Approved Section 4.55 (.....2.....) Modification Application

In respect to.....SSD 7484.....

SANDSTONE PRECINCT
23-39 BRIDGE STREET
SYDNEY, NSW, 2000

DEMOLITION ELEVATIONS LANDS BUILDING - SOUTH AND EDUCATION BUILDING - SOUTH

01
-
1:200
EDUCATION BUILDING - PROPOSED NORTH ELEVATION

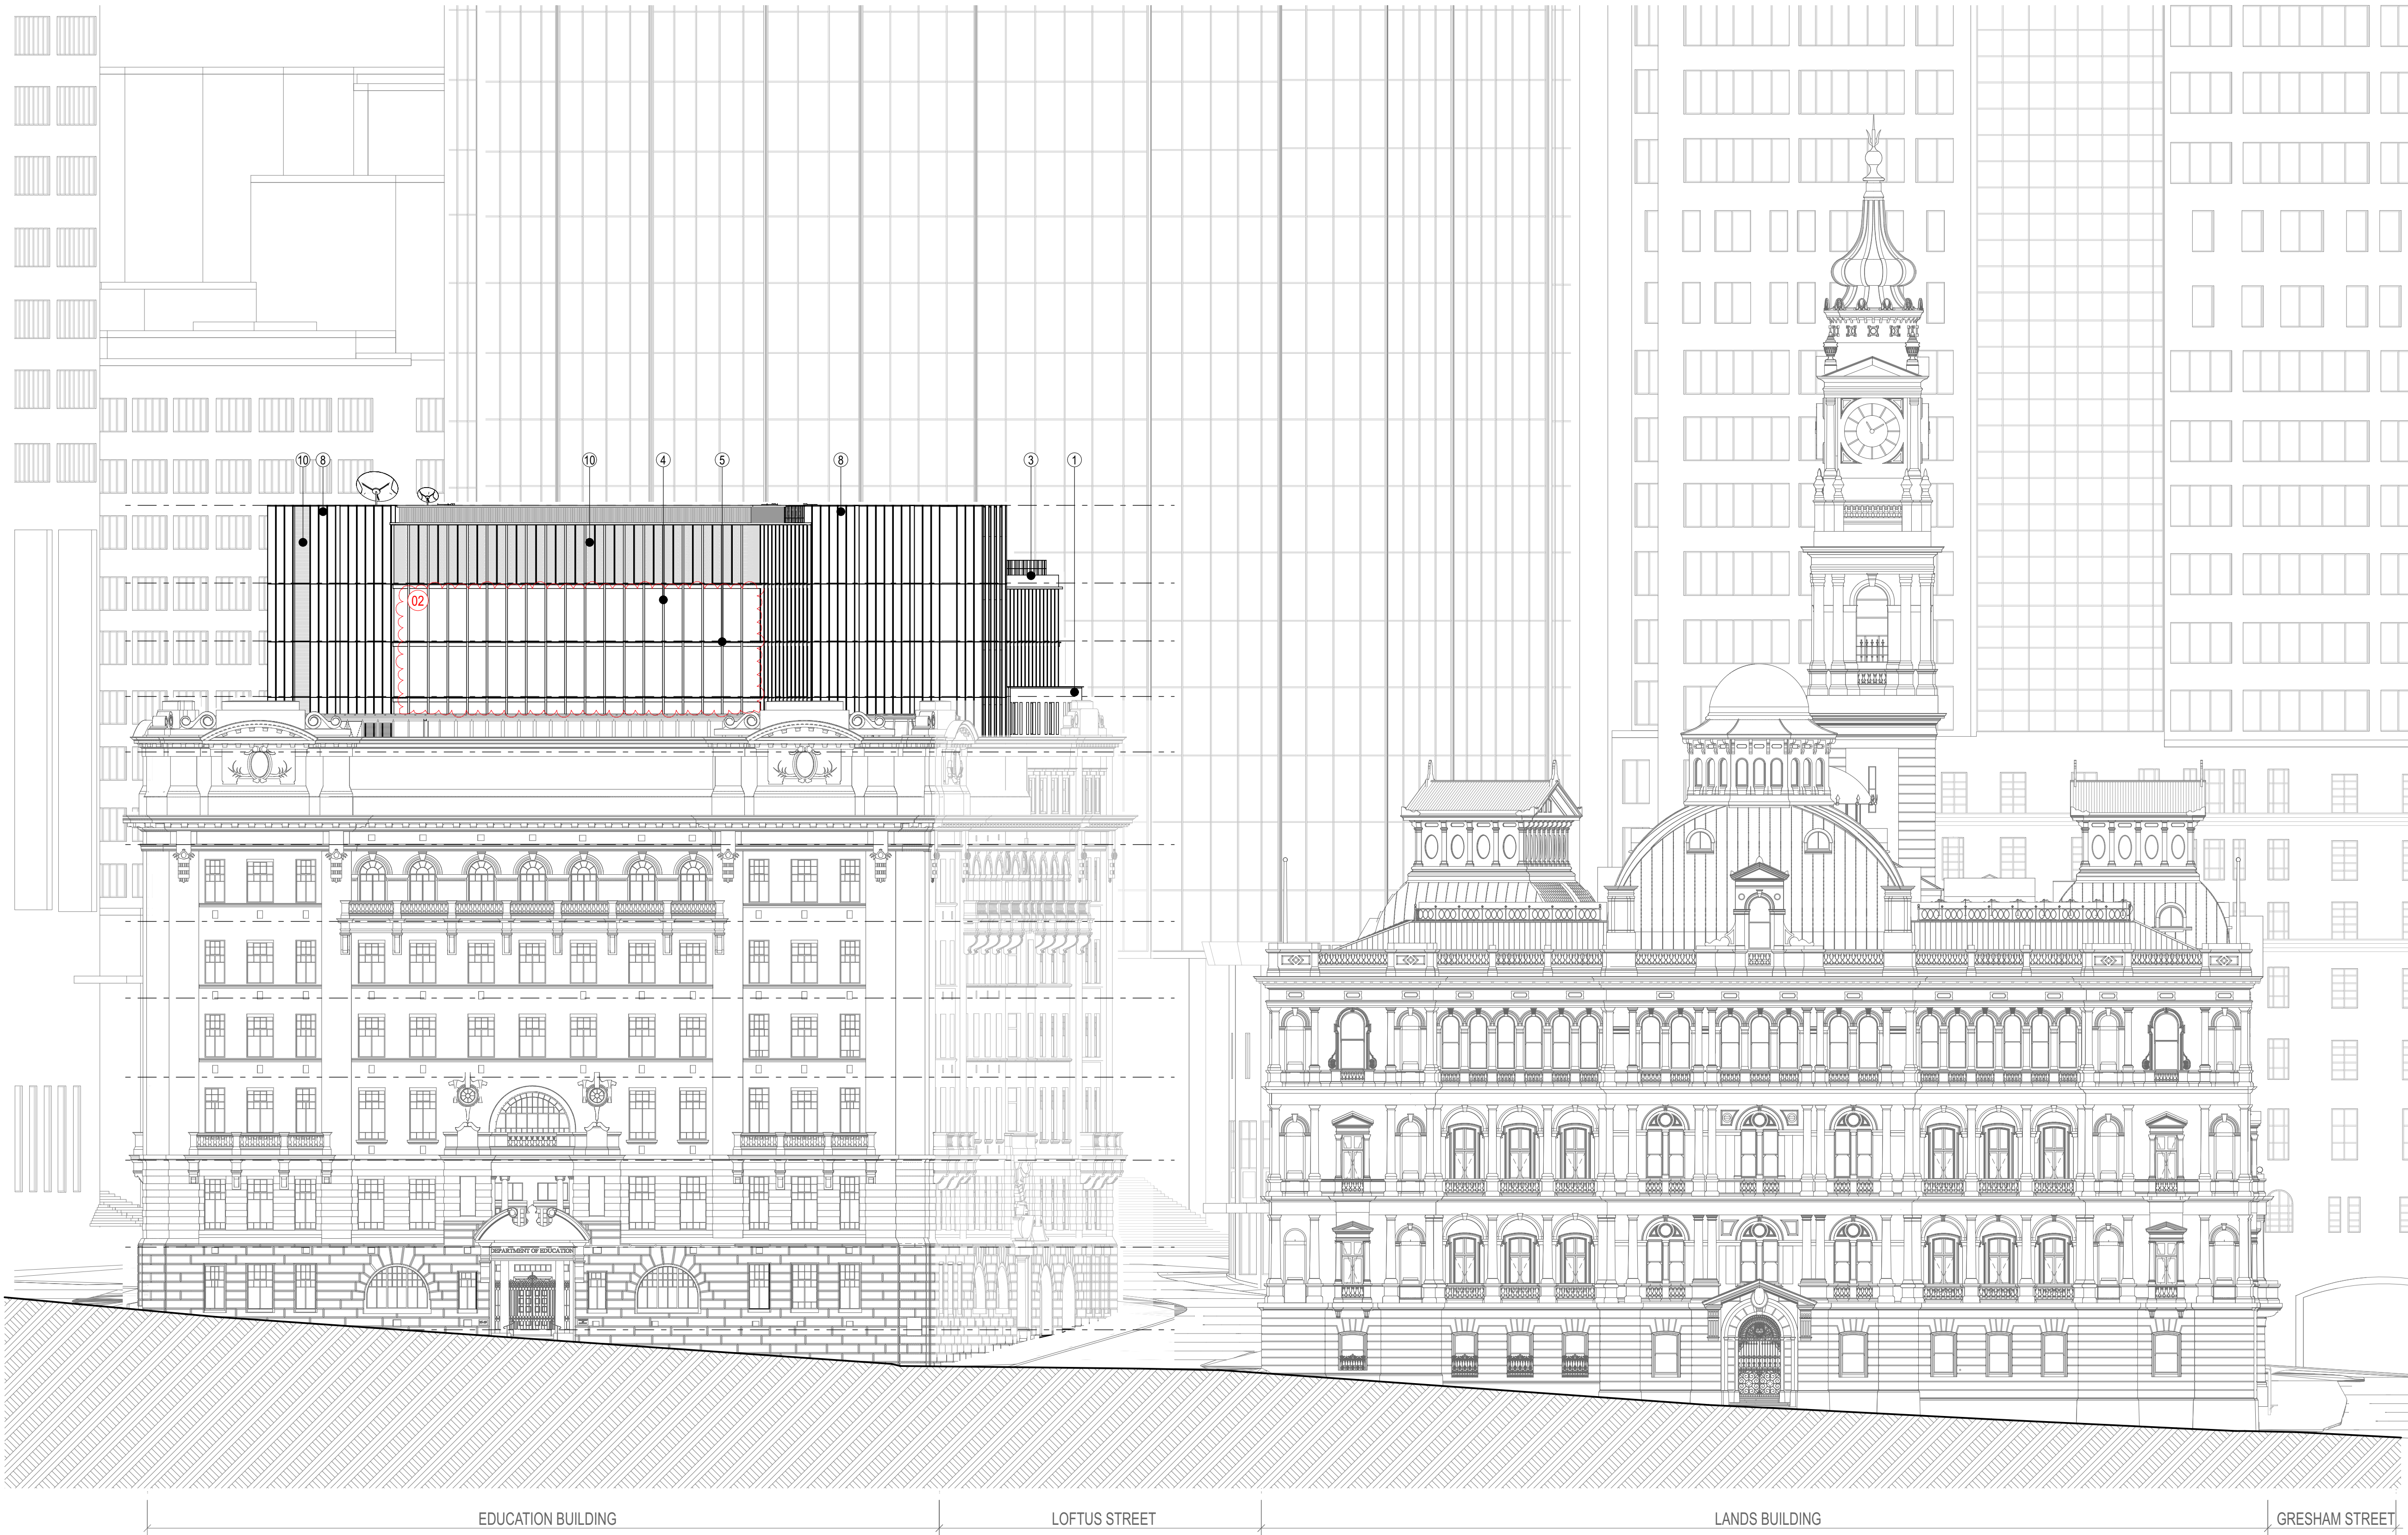
- CHANGES LEGEND:
- 01 CHANGED COLOUR TONED IN LEGEND
 - 02 REVISED CURTIN WALL SETOUT

01 EDUCATION BUILDING - PROPOSED WEST ELEVATION
1:200

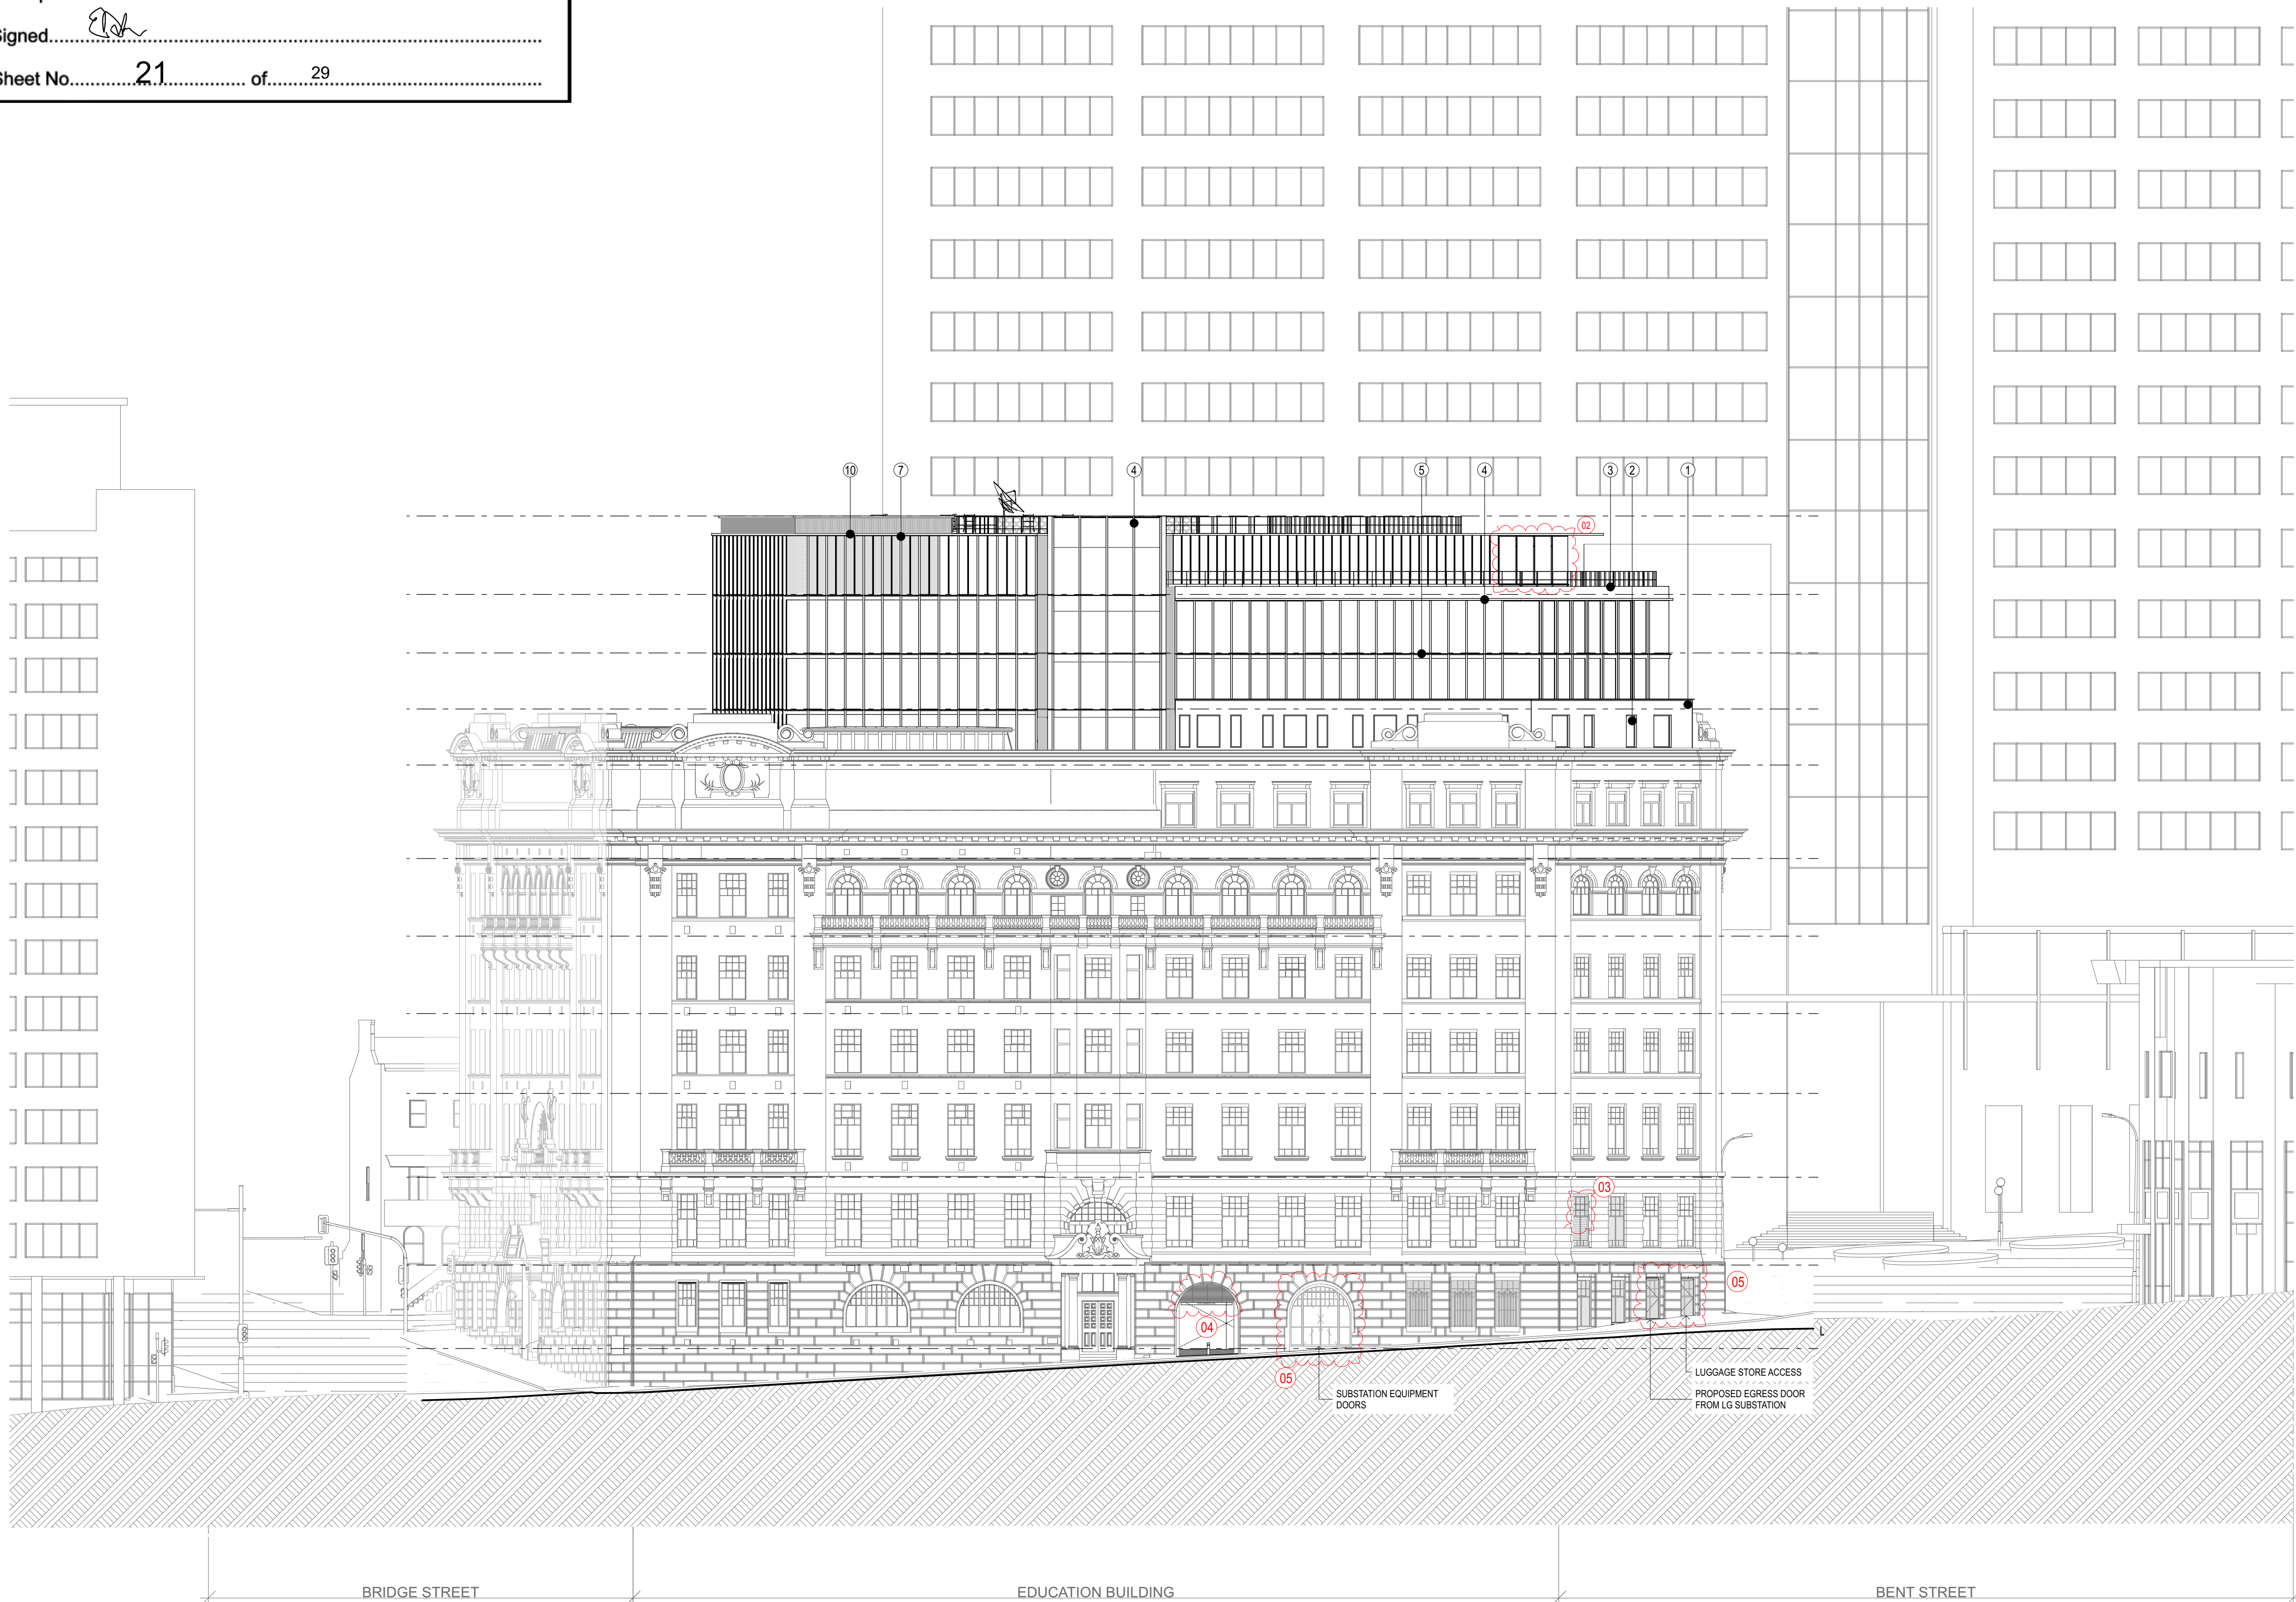
- 01 CHANGED COLOUR TONED IN LEGEND
- 02 DELETED EVERY SECOND FINIS
- 03 REPLACE EXISTING OPENING WITH NEW LOUIRE FOR SUBSTATION EXHAUST
- 04 REPLACE EXISTING OPENING WITH NEW LOUIRE FOR SUBSTATION INTAKE
- 05 DECORATIVE DOOR DETAILS ADDED
